CITY OF AUBURN BID ADDENDUM

**ADDENDUM #1**

Auburn Industrial Park

City of Auburn Bid Number: 2013-041

**DETAIL**  
OF TYPICAL UNDERGROUND CABLE INSTALLATION

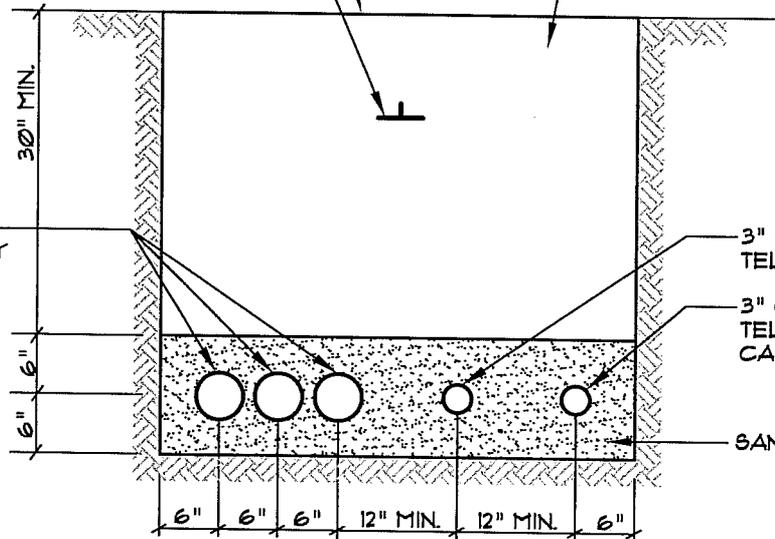
19. A revised "Typical Underground Cable Installation" standard detail is included with this addendum. This detail shall replace the "Typical Underground Cable Installation" detail shown on sheet 12 of the plan set.
